2027.00 Moss Lane East, Manchester

Design Co-ordination Amendments
New Building

Roof Plan as Proposed

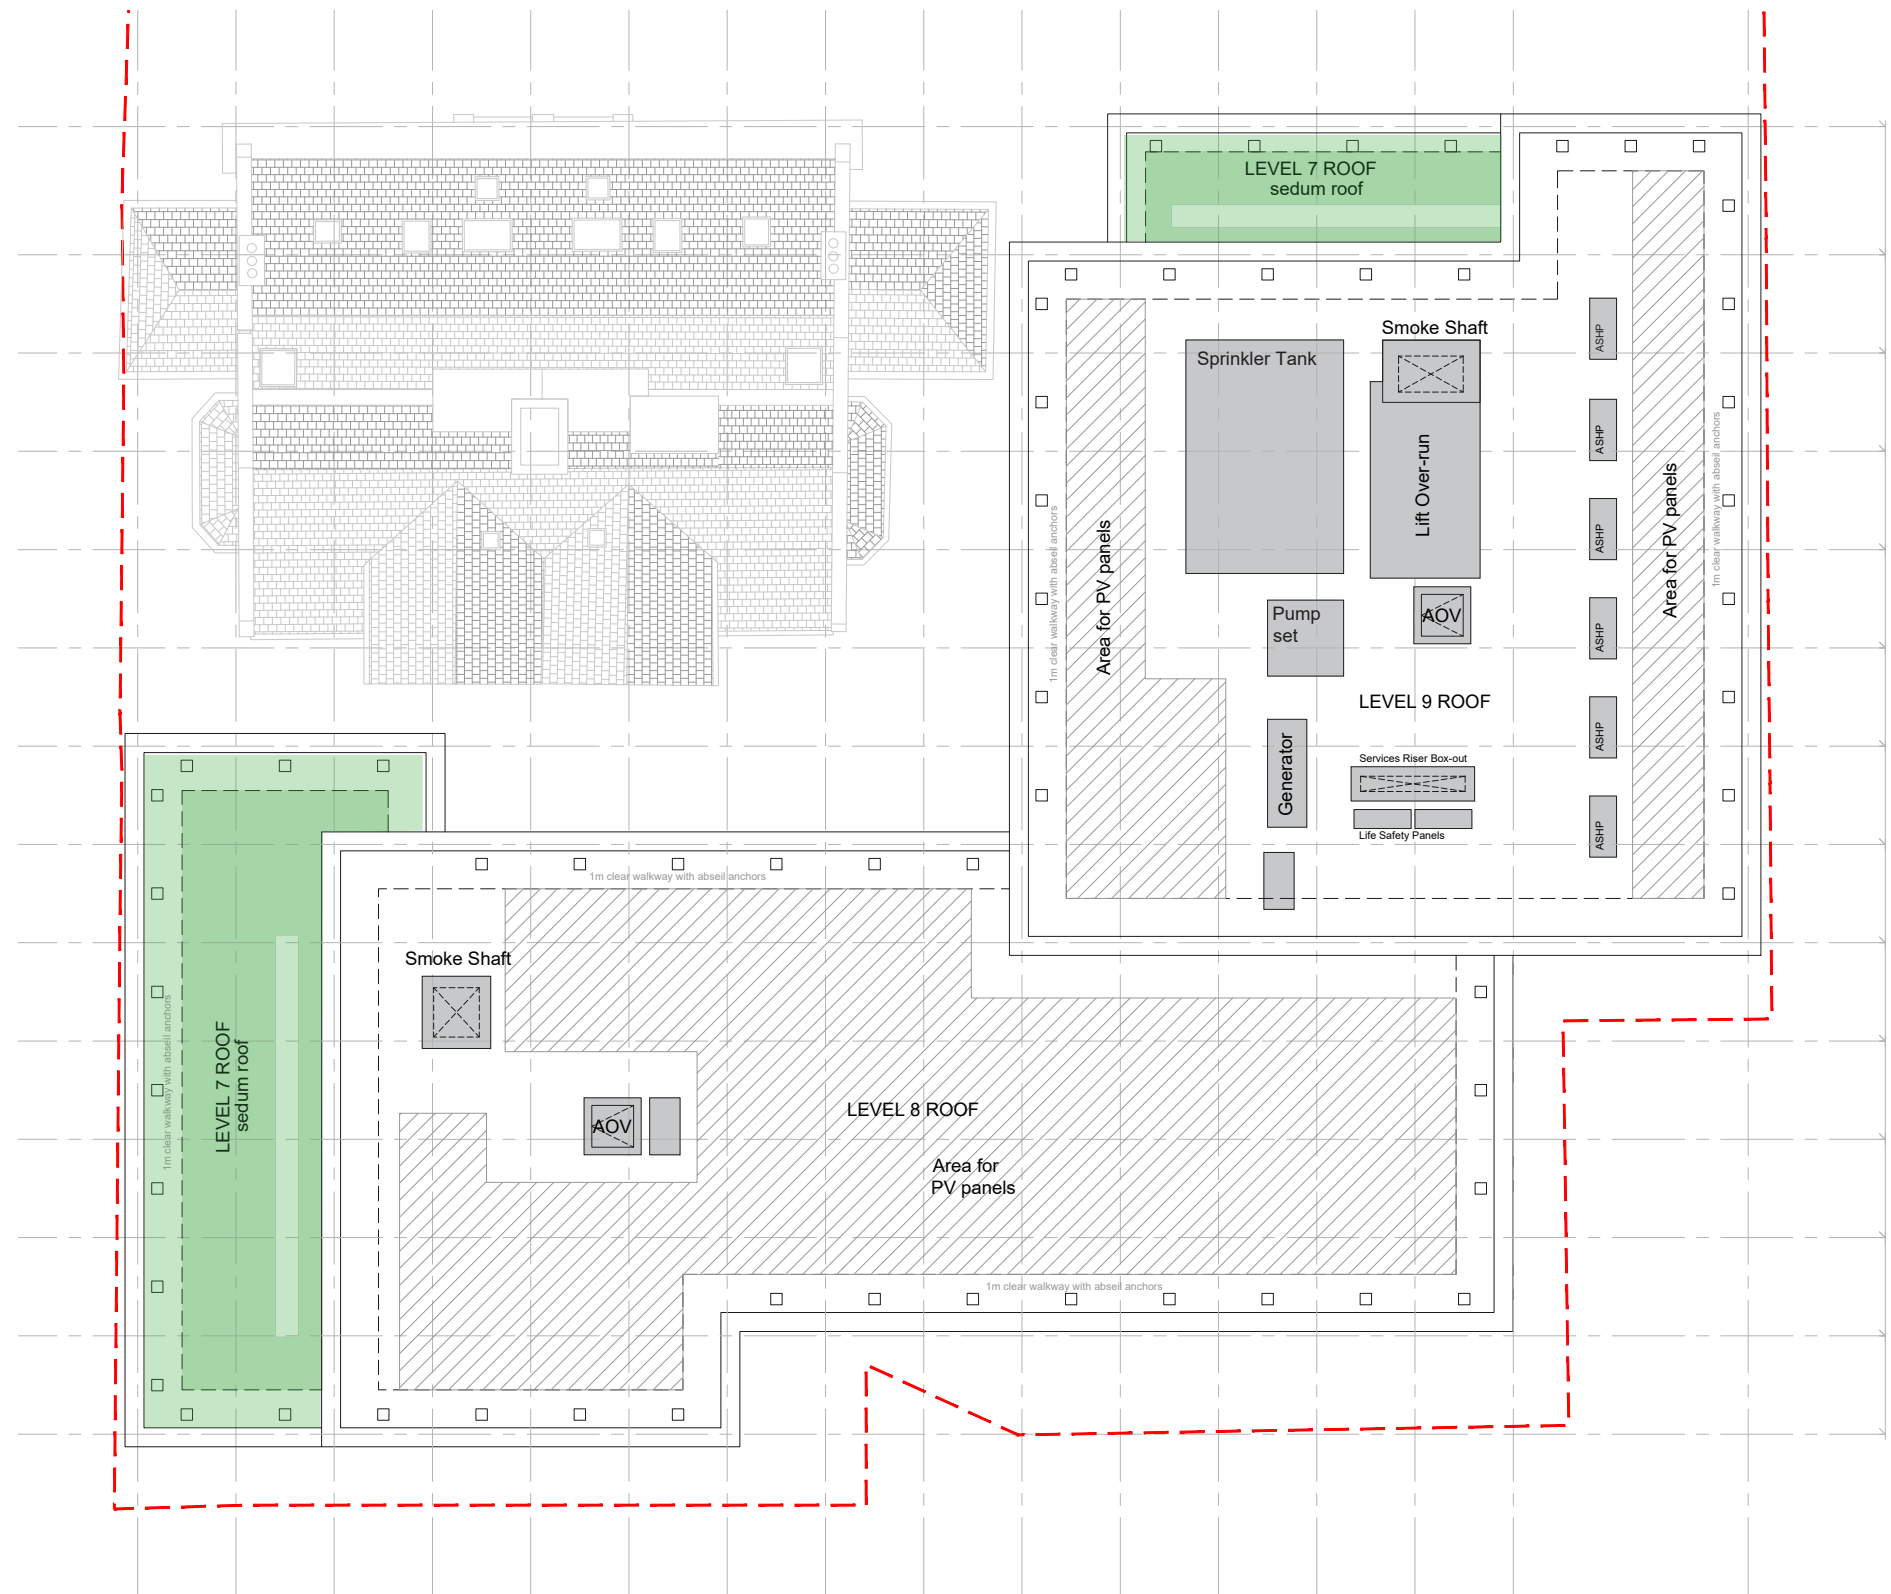
- In the consented design, the rooftops accommodated M&E equipment including PV panels, air-source heat pumps, back-up generator etc, all of which were distributed across level 7, 8 and level 9 roofs.
- Sedum roofs were proposed to Level 7, 8 and 9 roofs but almost entirely covered by PV panels and other M&E equipment.
- This unco-ordinated proposal makes application of green roofs unviable.

- In the current, updated design, the rooftop M&E equipment (PV panels) has been rationalized and limited to level 8 and 9 roofs.
- Sedum roofs have been omitted from level 8 and 9 roofs, and maintained at level 7 roofs where there is no M&E plant.
- Only level 7 roofs are overlooked by bedrooms so it makes sense to retain the green roofs in these locations.
- Biodiversity Net Gain has been improved with green enhancements at ground level areas that are visible from the street, are accessible by residents, and therefore considered to be of a higher value to the scheme.

Part Plan and West Elevation as Consented

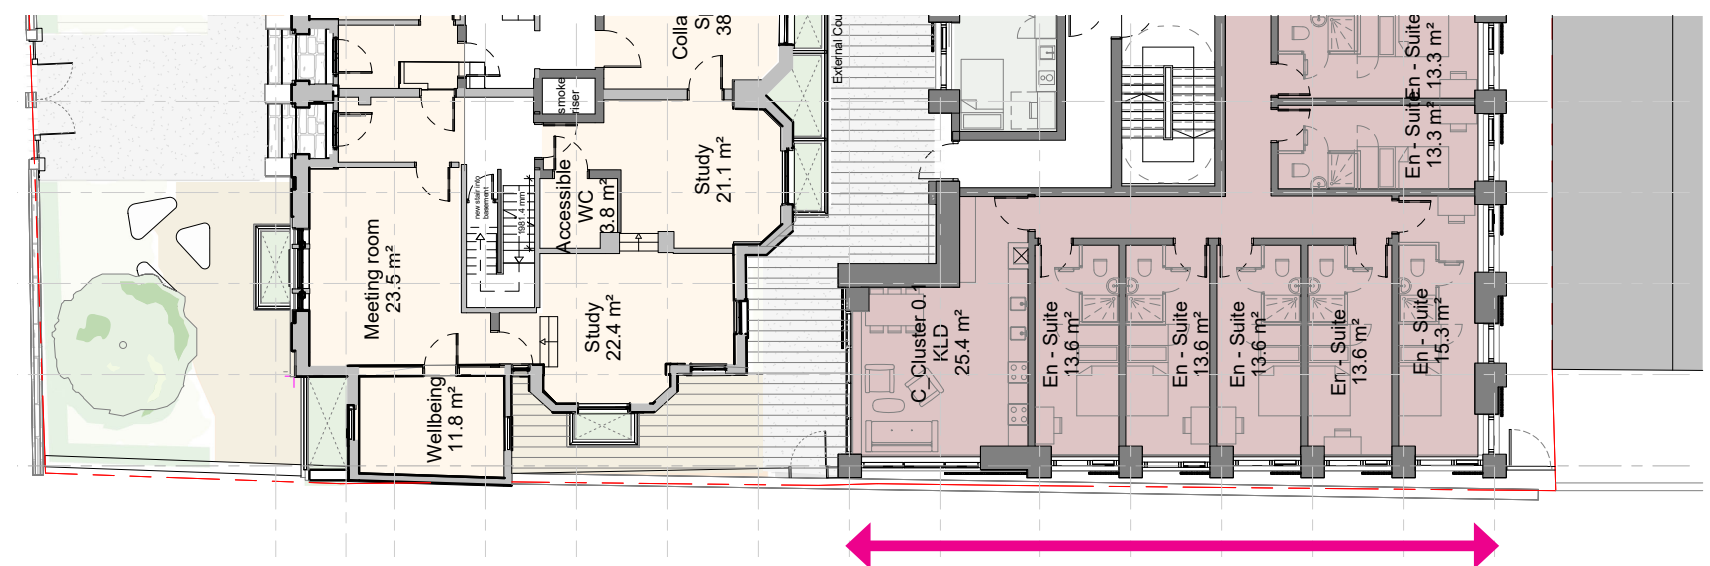
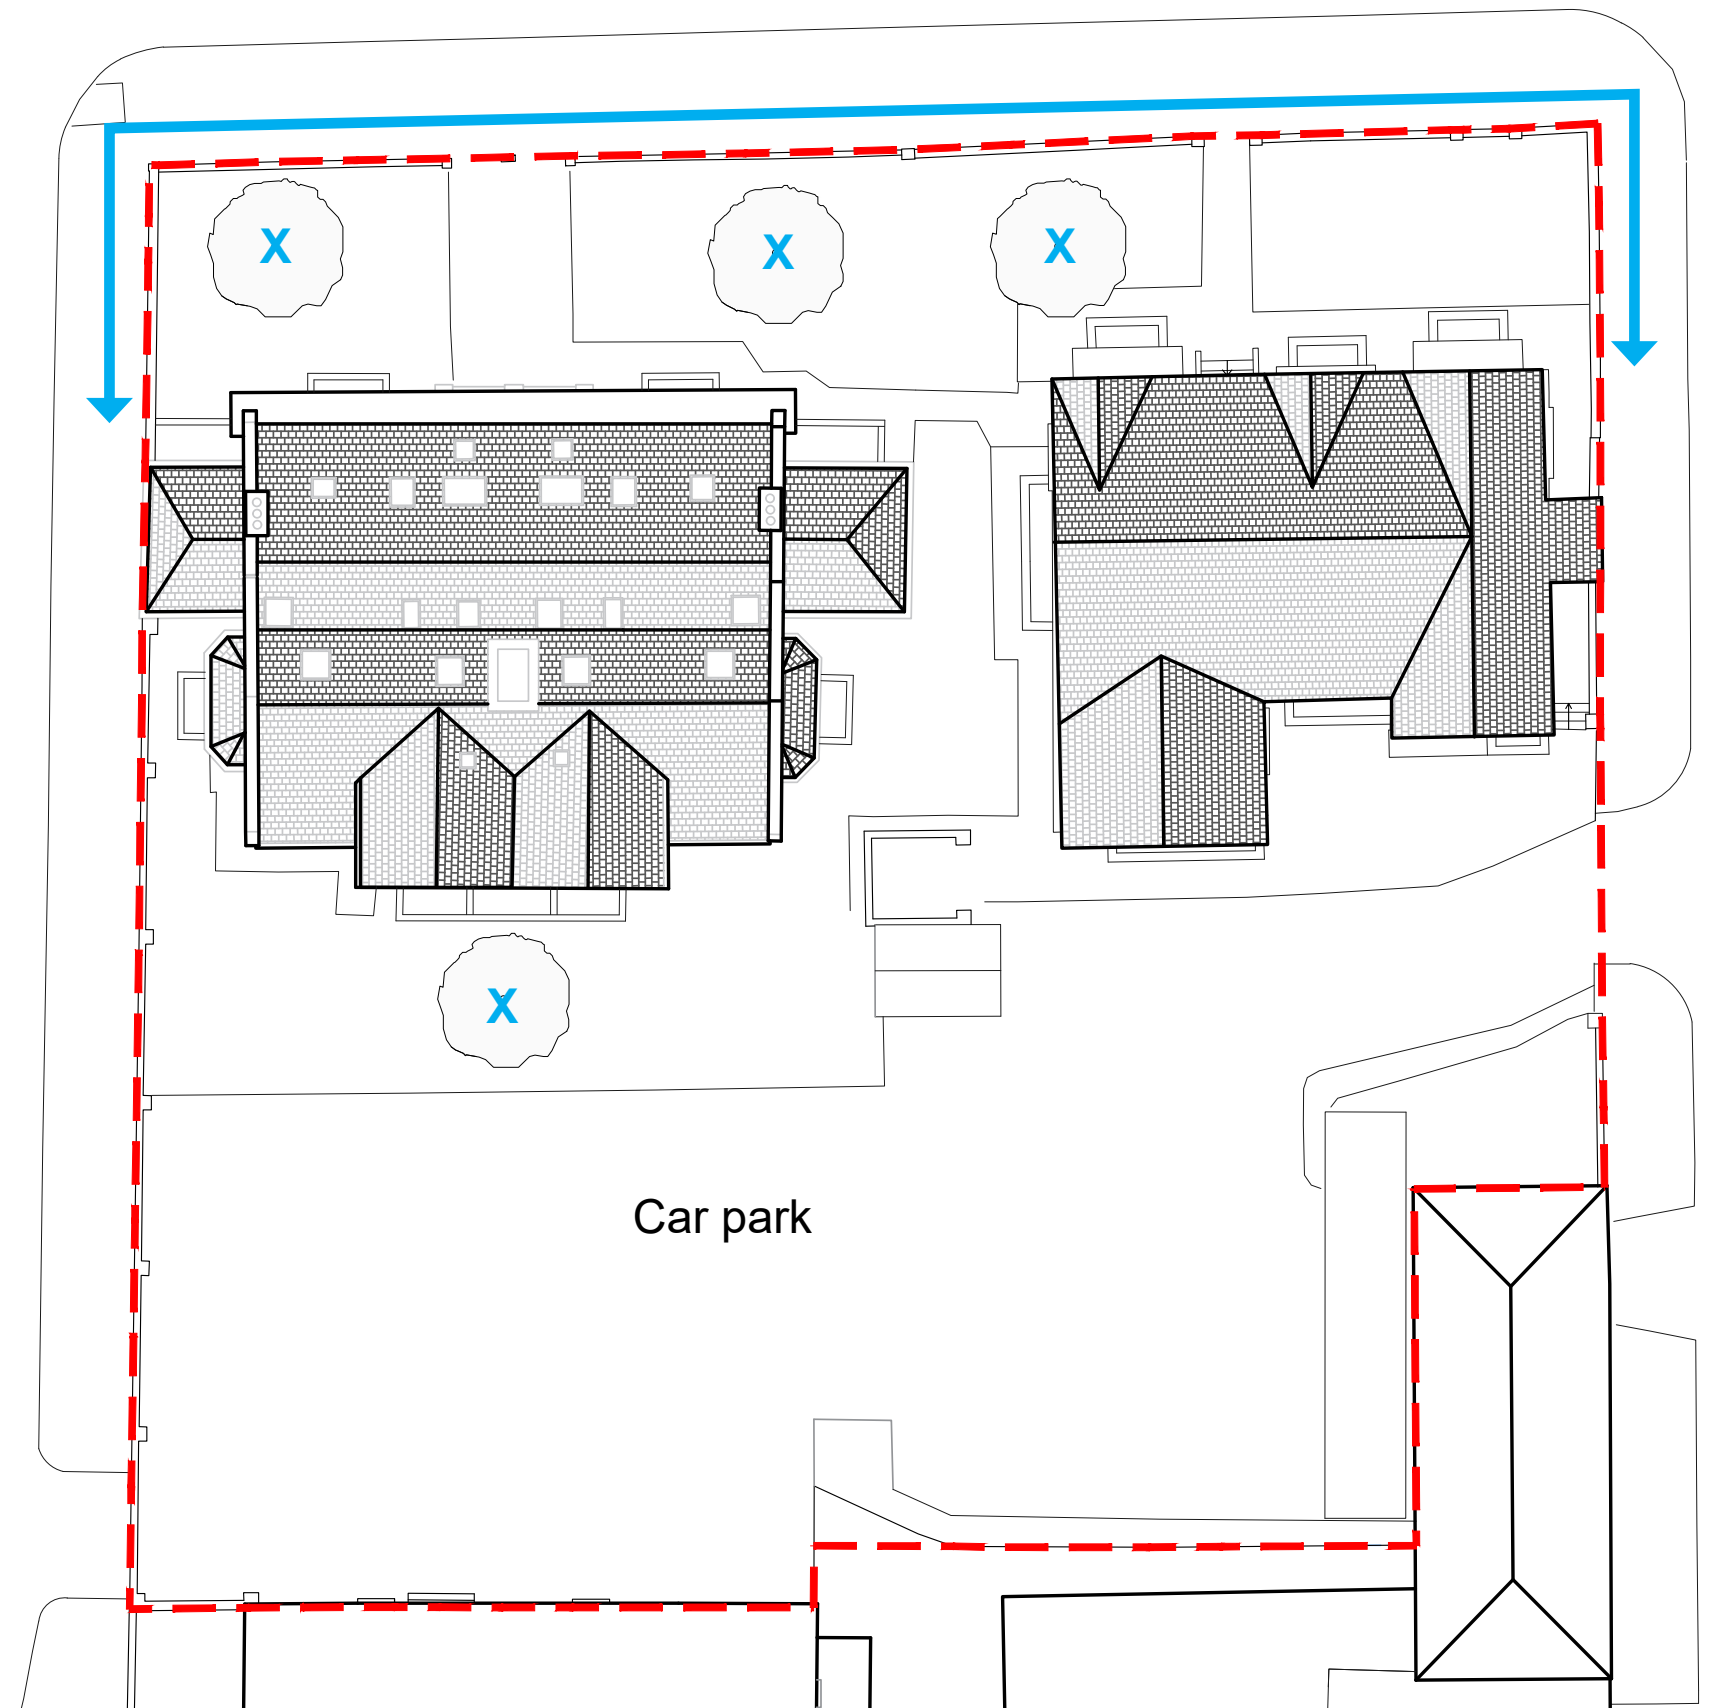
- The consented proposals appear to show a discrepancy in architectural drawings - the West Elevation drawing shows the existing brick boundary wall intact along its length, whereas the Ground Floor Plan shows the west facade sitting on line of the boundary wall with gates either side.
- Section 7 Landscaping of the DAS document makes reference to approx. half of this brick wall to be removed.
- This is considered a discrepancy and the updated proposals seek to align the drawings with the true original intent, as shown in the consented plan layouts.

- It is assumed that a localized removal of this brick boundary wall was always part of the original design, which also seems logical given the proximity of the building to the boundary.
- The adjacent image shows the proposed West elevation in line with what is believed to be the original design intent.

Site Logistics Plan as Proposed

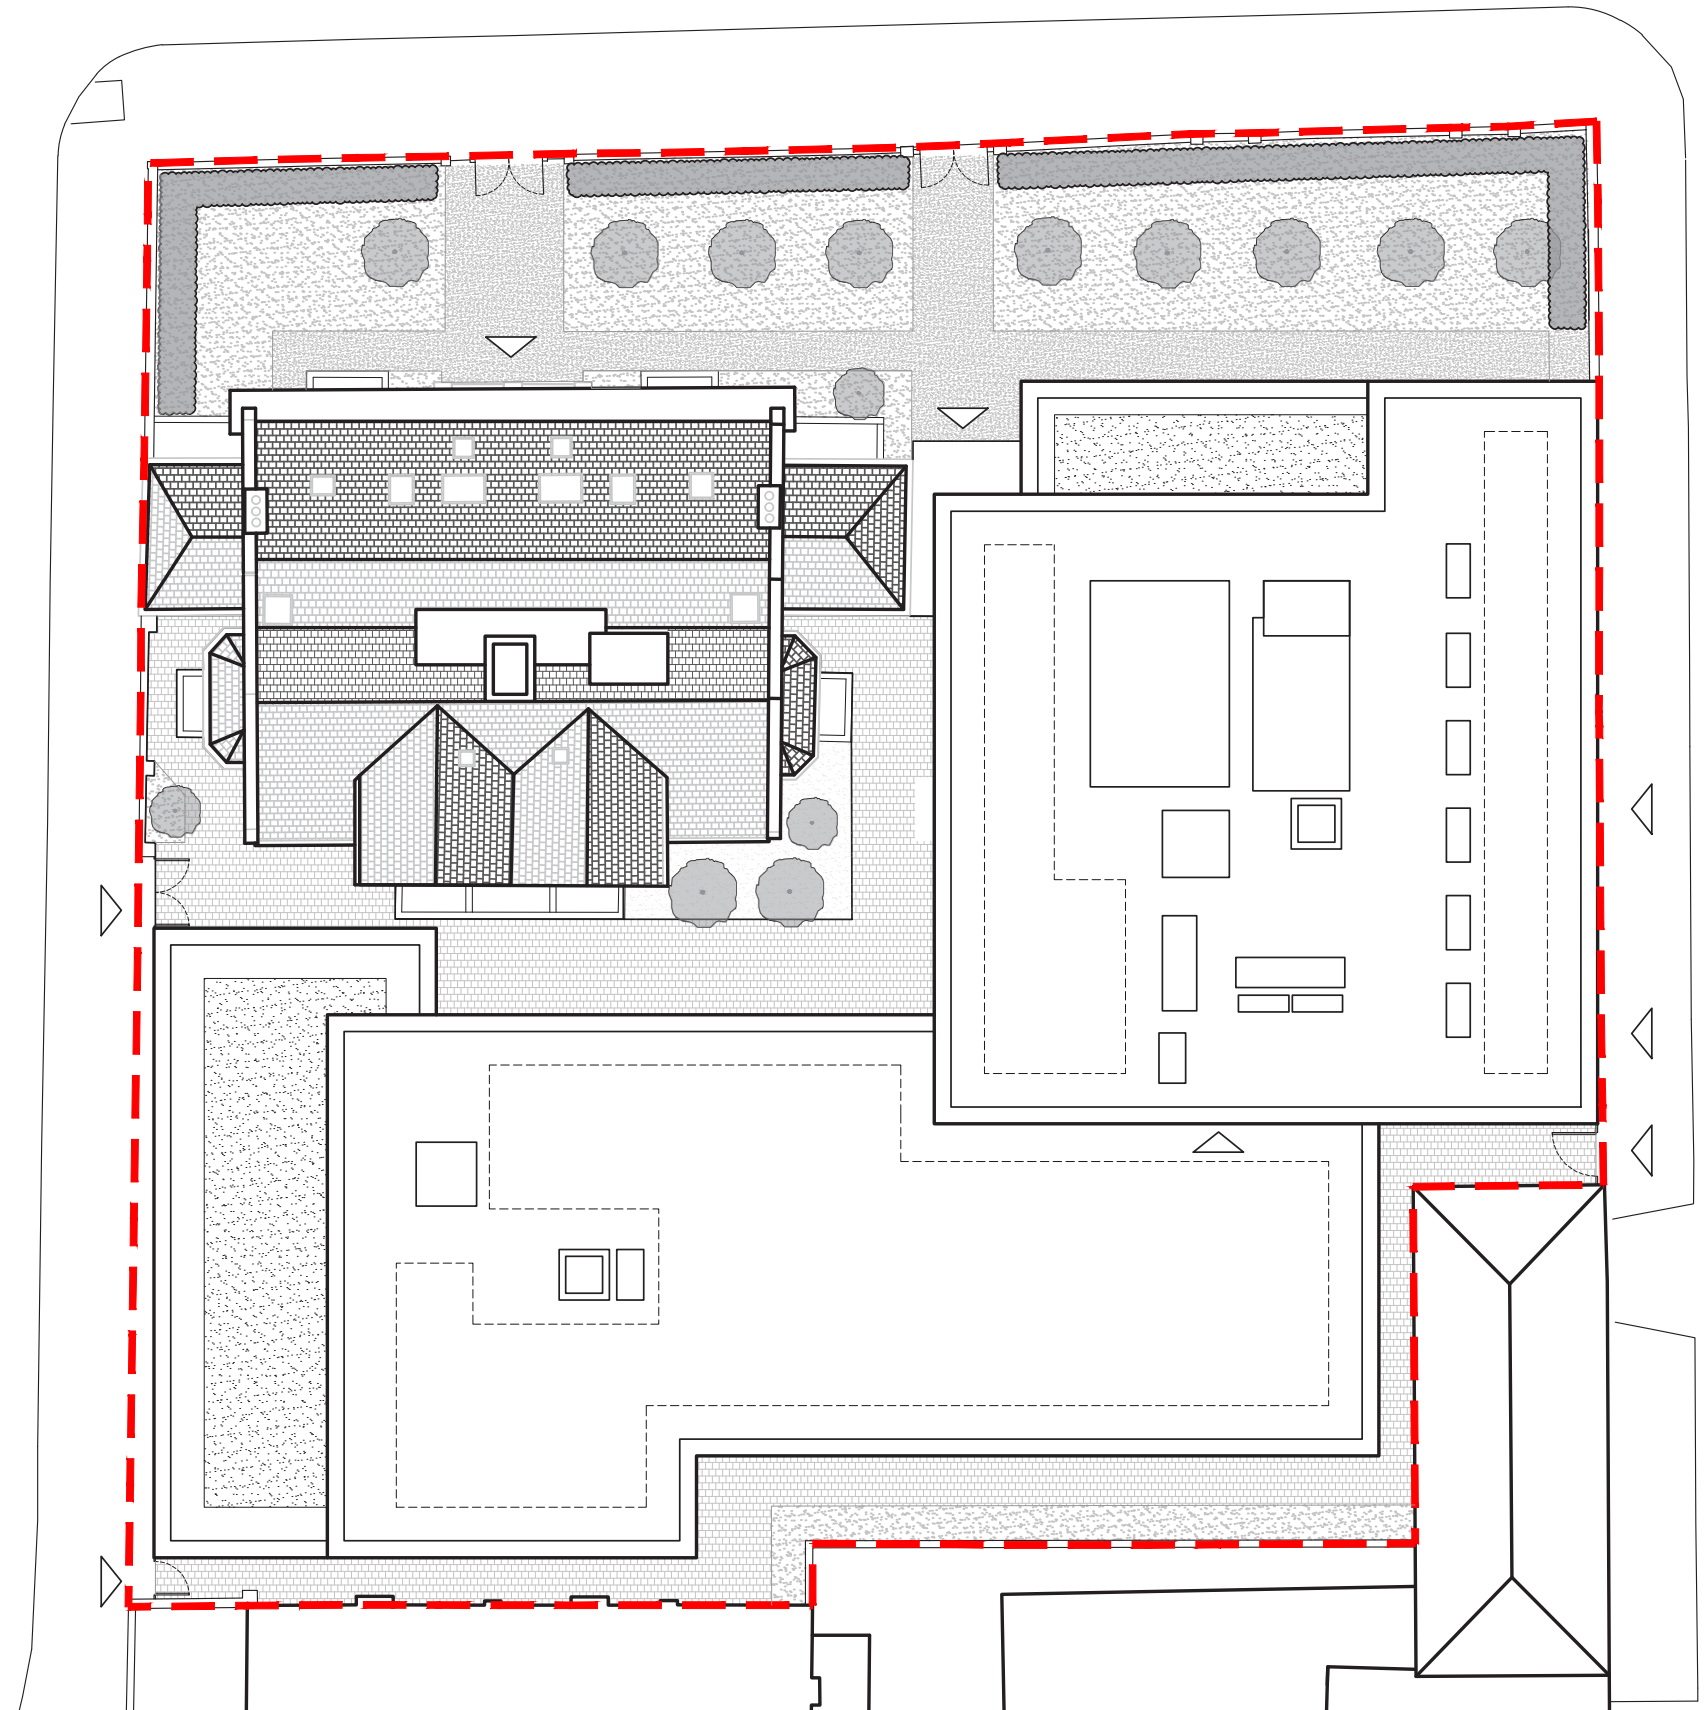
- Further arboricultural assessment of the existing trees on site reveals that their condition is poor and recommendation for removal has been tabled.
- In addition to this, it is also proposed to temporarily remove portion of the existing boundary wall and fence at the north of the site (highlighted in blue) to facilitate primary access during construction works. This temporary measure is driven by the constrained nature of the site in a sensitive residential area and what is acceptable by MCC Highways Department.

- The adjacent diagram indicates the proposed site logistics, including access, site compound, construction phasing.
